CITY OF PANAMA CITY BEACH

ADDENDUM NO. 1

PCB23-35 ITB Conservation Park Classroom

Bidder Questions and Responses:

ALTERNATE NO. 1

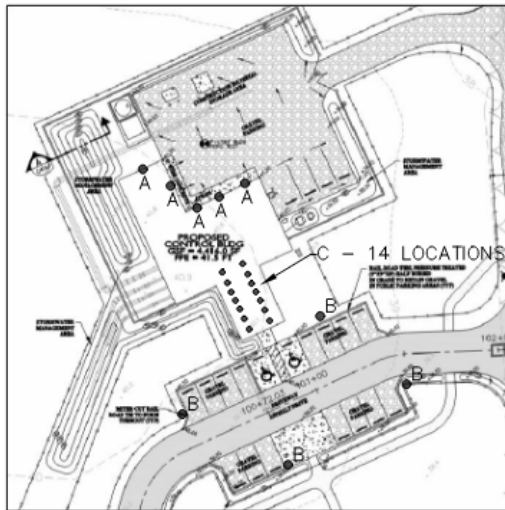
5. On the Bid Form, Alternate #1 indicates to include Kitchen Appliances. I only see a refrigerator on the drawings – is this the only appliance and is there a basis of design for the appliances?

R5. Refer to the table on Sheet A-401 indicating fixtures, furniture and equipment to be provided, reprinted below.

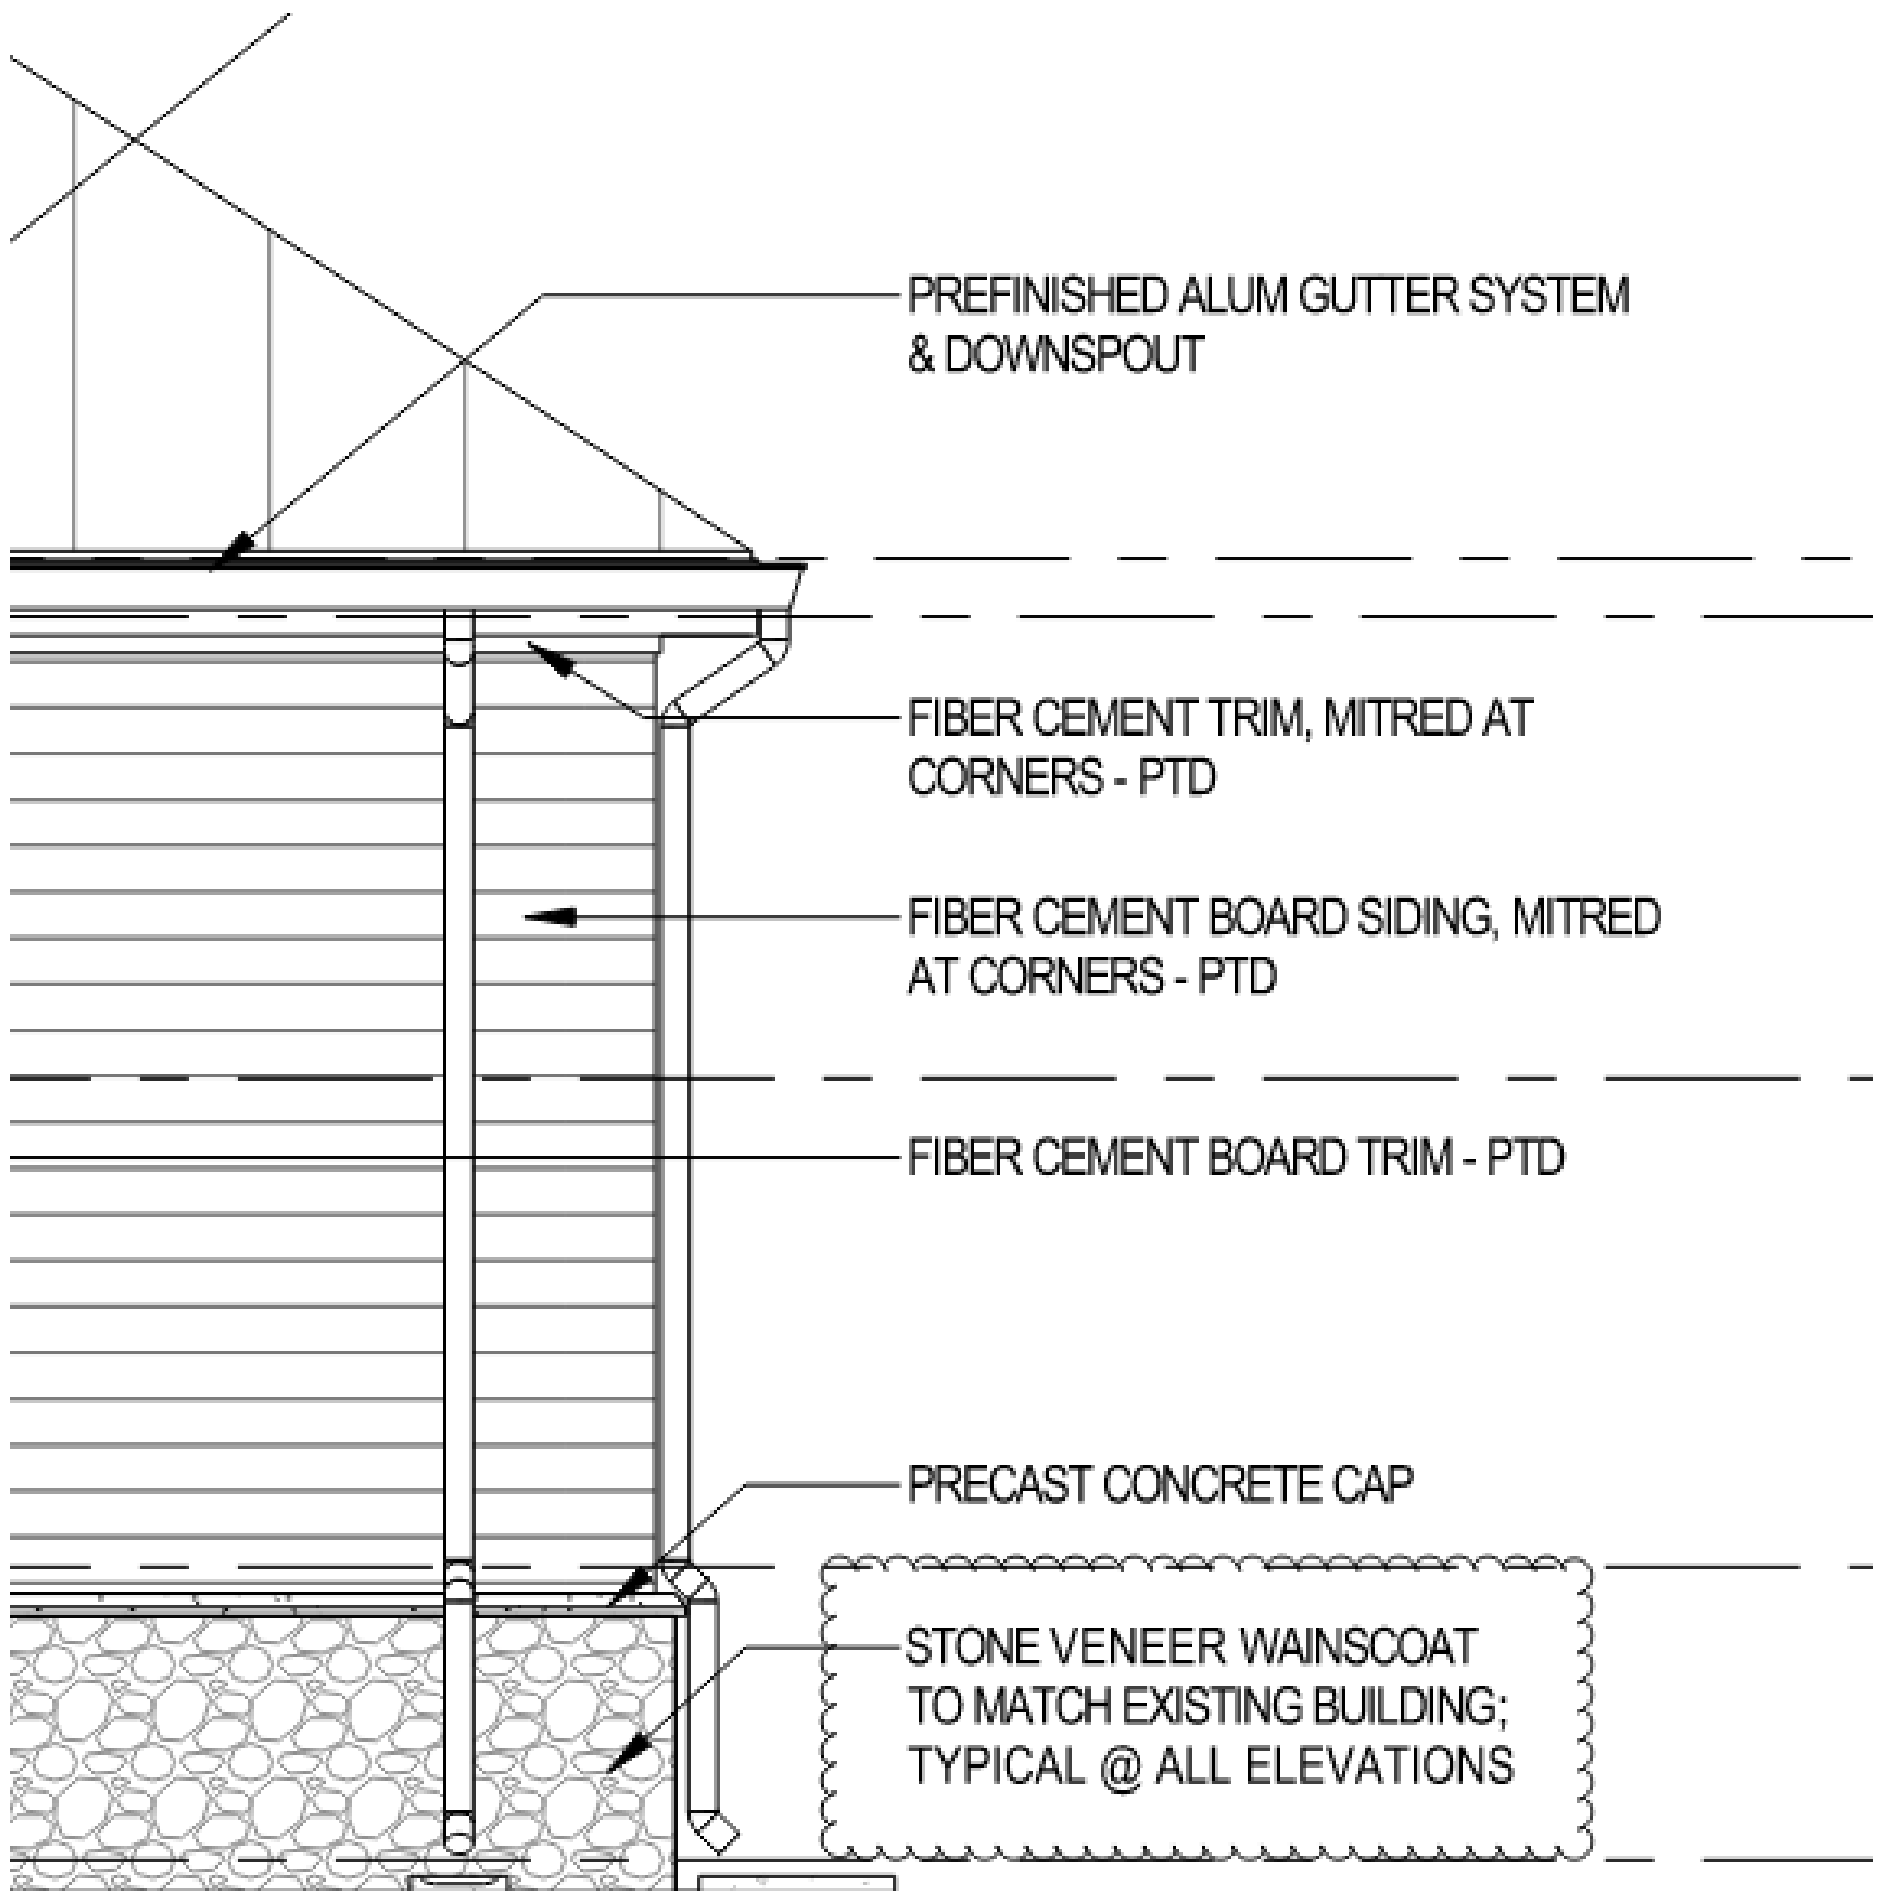
7. Are the interior walls wood framed or metal stud?

R7. *We have a wood top plate for the trusses and wood trusses, so wood studs will be fine.*

SK-1

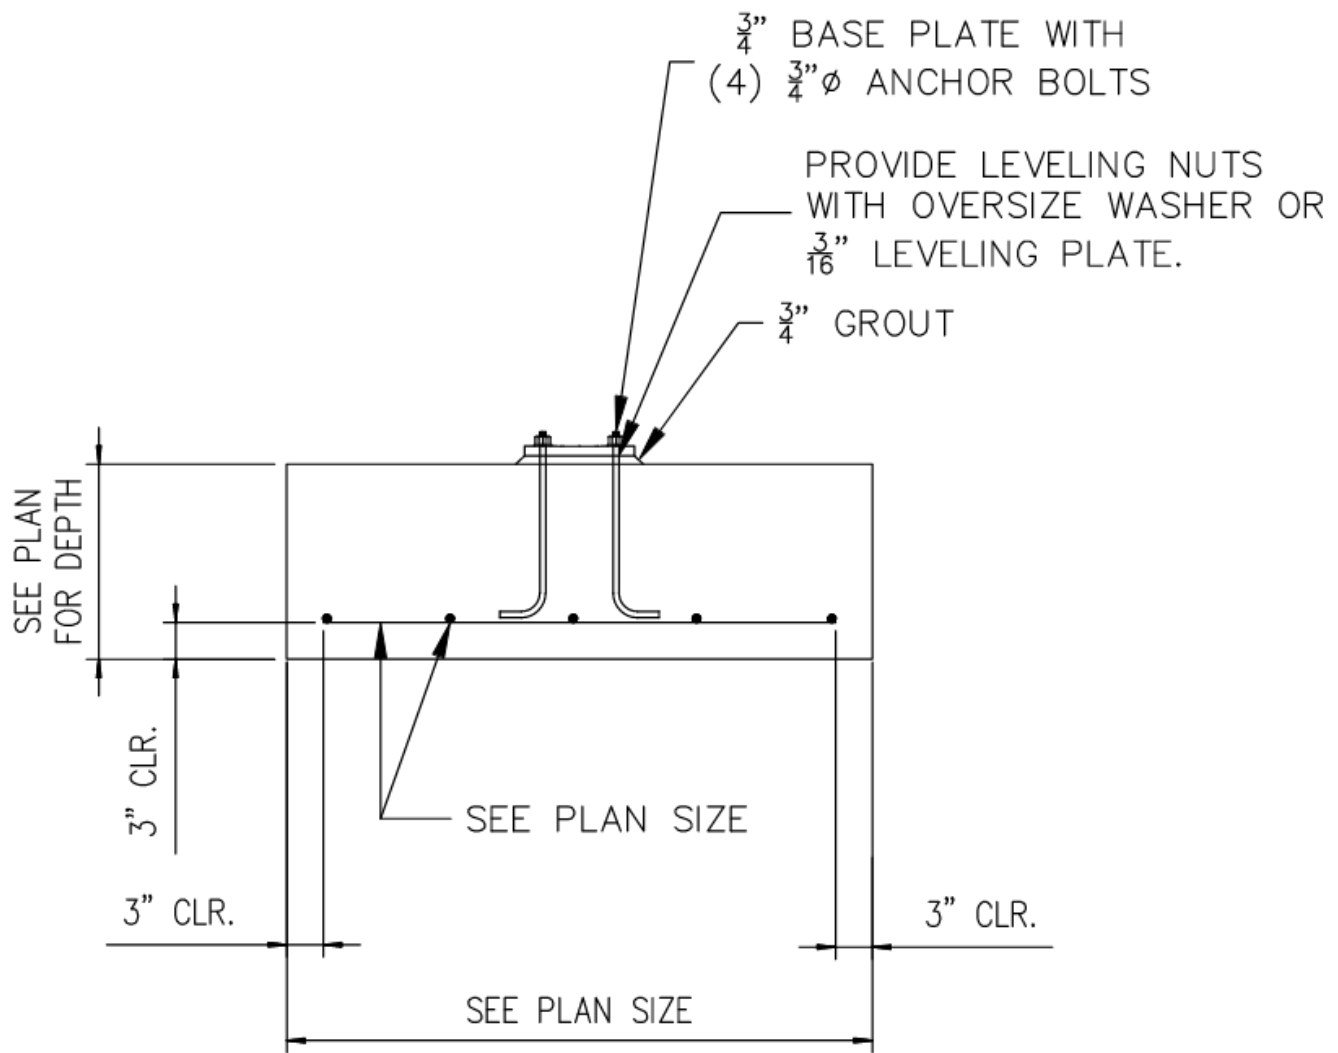
4. Is there a material specification available for the stone veneer?

R4. *Refer to SK-1 (attached); there was no spec available for the existing building stone we were asked to match, so our notes read "to match existing building".*

STONE VENEER WAINSCOAT TO MATCH EXISTING BUILDING; TYPICAL @ ALL ELEVATIONS
